WARRANTY BULLETIN SAFETY CAMPAIGN

Campaign no.: 2023-0013

December 21, 2023 Subject: **Rearview Mirror Lenses May Dislodge - Decreased Visibility**

No. **2023-9**

REARVIEW MIRROR ASSEMBLY REMOVAL

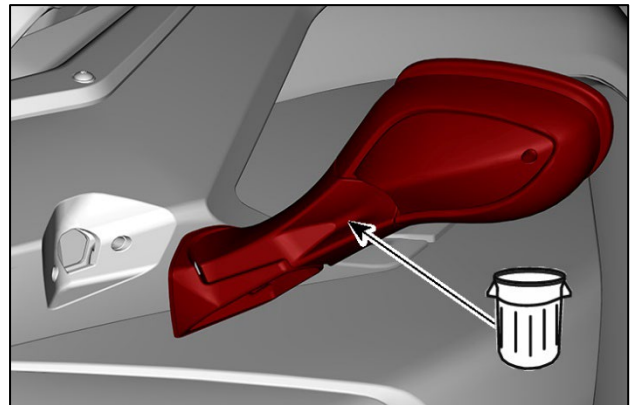
The rearview mirror lenses may dislodge from the housing. This can result in an increased risk of a crash due to the decreased visibility for the driver.

Replace both rearview mirror assemblies.

1. Remove and discard the two retaining screws.

2. Discard the rearview mirror assembly.

3. Clean threads on vehicle.

The installation is the reverse of the removal procedure.

TIGHTENING TORQUE	
Mirror assembly retaining screw	3.5 N•m ± 0.5 N•m (31 lbf•in ± 4 lbf•in)
